QUALITY ASSURANCE -- NON-CONFORMANCE REPORT

Report No: NCR-000597

Reference Description: ZPMC performed base metal repairs without the Engineer's approval in Segment 6AW Deck Plate

Job Name: SAS Superstructure

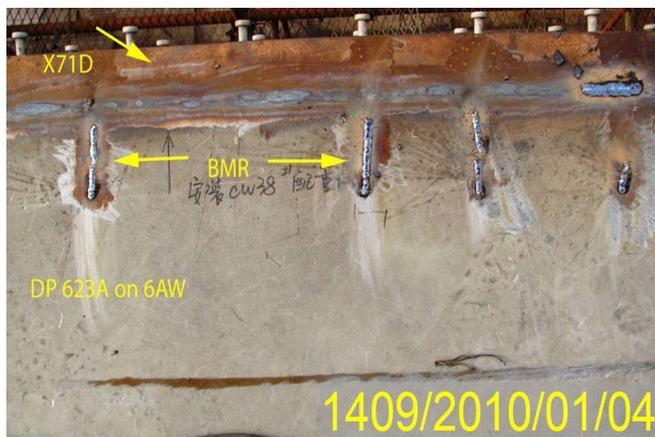
- Base metal repairs (BMR) were being performed that were discovered from the removal of temporary attachments on a Deck Plate, without the prior approval of the Engineer.
- There are a total of 22 locations of these base metal repairs.
- The approximate length of the BMR is random. They are running adjacent to the X71D Counter Weight attachment plate.
- The Counterweight side of Deck Plate is identified as: DP623A
- The Counterweight attachment plate is identified as X71D.
- The material is A709M Grade 345 non SPCM.
- Deck Plate is located on top of Segment 6AW in the Trial Assembly area.

Special Provisions Section 8-3.01: "The Engineer shall be notified immediately in writing when welding problems, deficiencies, base metal repairs, or any other type of repairs not submitted in the WQCP are discovered and also of the proposed repair procedures to correct them. For requests to perform repairs, the contractor shall include an engineering evaluation of the proposed repair."

CT/ABF and ZPMC have established a procedure in which non-SPCM temporary attachment removal base metal repairs are performed in accordance with procedure TA100 supplemented with a WRR that contains a pre-established weld repair disposition as agreed to by CT, ABF and ZPMC. The WRR will reference the location and number of areas to be weld repaired. The QA inspector will be notified prior to weld repairs for the purposes of performing QA verification if of the areas prepared for welding. The QA inspector will also be notified when the finished weld repair has been accepted by ZPMC and ABF for QA verification. The WRR and applicable weld procedure must be available on site during the welding operation.

The documentation submitted by the contractor has been reviewed by the Engineer and is found to be acceptable.

Reference Description: Base Metal Repair on Segment 10AW Deck Panel without Engineer's Approval

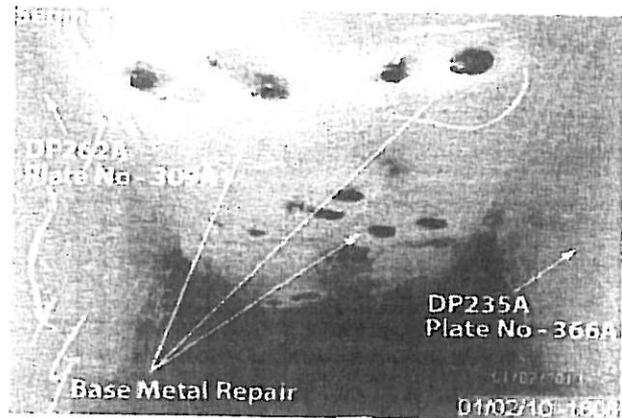
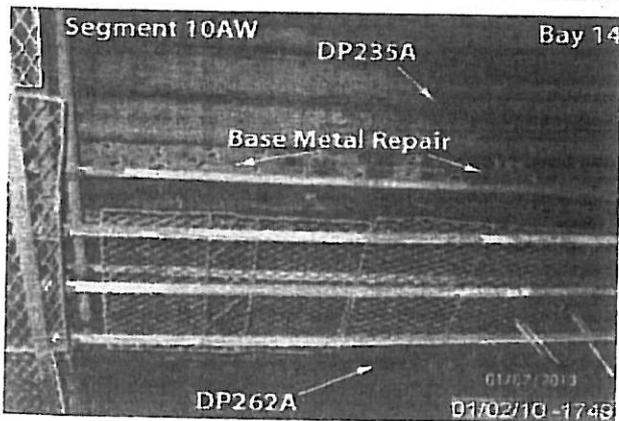
- During the Quality Assurance (QA) random in-process visual inspection of Orthotropic Box Girder (OBG) Segment 10AW, this QA inspector discovered the following issue:
- Base metal repairs were being performed that were caused by the removal of temporary attachments on two (2) Deck Plates, without the prior approval of the Engineer.
 - The Deck Panels are identified as: DP262A (PL309A) and DP235A (PL366A)
 - The weld splice joining Deck Panels DP262A and DP235A are identified as: SEG059*007
 - The steel deck material is A709 Grade 345 non SPCM.

Caltrans Special Provision Section 8-3.01: "The Engineer shall be notified immediately in writing when welding problems, deficiencies, base metal repairs, or any other type of repairs not submitted in the WQCP are discovered and also of the proposed repair procedures to correct them. For requests to perform repairs, the contractor shall include an engineering evaluation of the proposed repair."

Propose a resolution for the identified non-conformance with revised procedures to prevent future occurrences. Notify the engineer prior to starting base metal repair. A response for the resolution of this issue is expected within 7 days.

Reference Description: ZPMC performed base metal repairs without the Engineer's approval in Segment 6AW Deck Plate

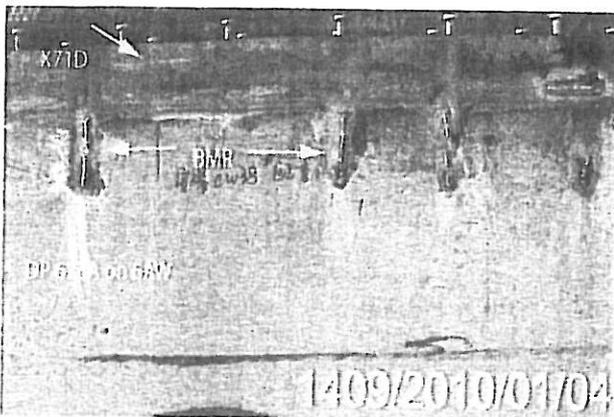
- Base metal repairs (BMR) were being performed that were discovered from the removal of temporary attachments on a Deck Plate, without the prior approval of the Engineer.
- There are a total of 22 locations of these base metal repairs.
- The approximate length of the BMR is random. They are running adjacent to the X71D Counter Weight attachment plate.
- The Counterweight side of Deck Plate is identified as: DP623A
- The Counterweight attachment plate is identified as X71D.
- The material is A709M Grade 345 non SPCM.
- Deck Plate is located on top of Segment 6AW in the Trial Assembly area.

Special Provisions Section 8-3.01: "The Engineer shall be notified immediately in writing when welding problems, deficiencies, base metal repairs, or any other type of repairs not submitted in the WQCP are discovered and also of the proposed repair procedures to correct them. For requests to perform repairs, the contractor shall include an engineering evaluation of the proposed repair."

In accordance with the Fabrication Procedures, the Contractor is not required to obtain the Engineer's approval prior to performing base metal repairs resulting from temporary attachment removal on non-SPCM material. Further discussions have led to a mutual agreement that WRRs will be used to track the locations of such base metal repairs on non-SPCM members.

Reference Description: Base Metal Repairs without Engineer's Approval, Segment 7CW

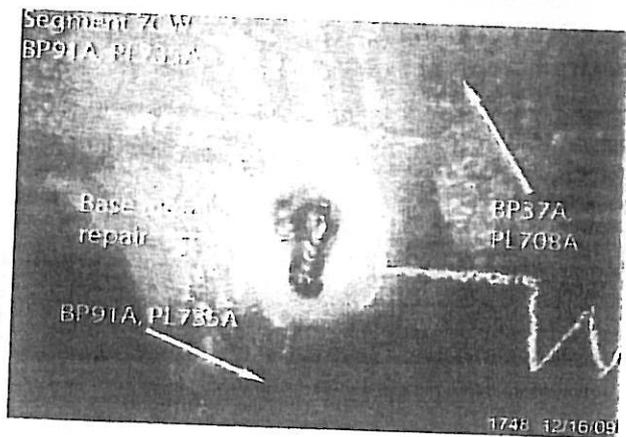
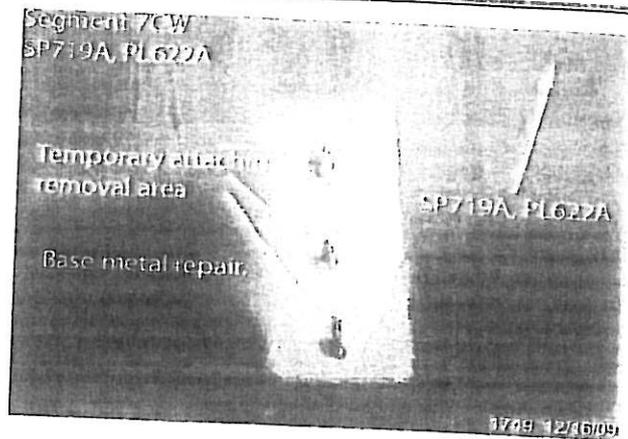
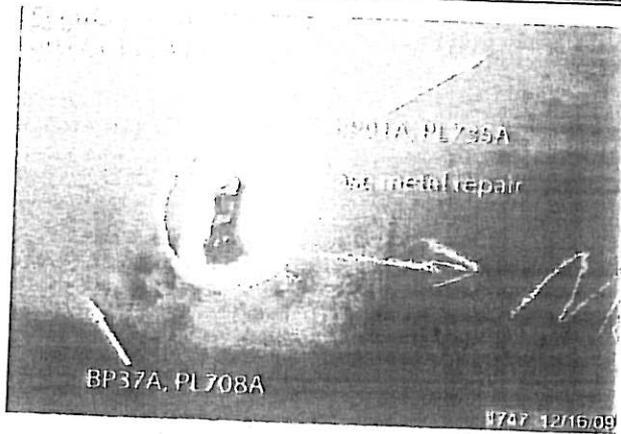
-Base metal repairs being performed in way of temporary attachment removal areas on the bottom and side plates without the prior approval of the engineer.

- SP126A, Plate number-PL250A
- SP153A, Plate Number-PL533A
- SP719A, Plate Number-PL622A
- SP481A, Plate Number-PL621A
- SP440A, Plate Number-PL1279A
- BP91A, Plate Number-PL735A
- BP37A, Plate Number-PL708A
- BP145A, Plate Number-PL789A
- The material is A709 Grade 345 non SPCM

Standard Specifications (99) section 8-3.01: "The Engineer shall be notified immediately in writing when welding problems, deficiencies, base metal repairs, or any other type of repairs not submitted in the WQCP are discovered and also of the proposed repair procedures to correct them. For requests to perform repairs, The contractor shall include an engineering evaluation of the proposed repair."

Submit a repair procedure to the engineer for approval. A response for the resolution of this issue is expected within 7 days.
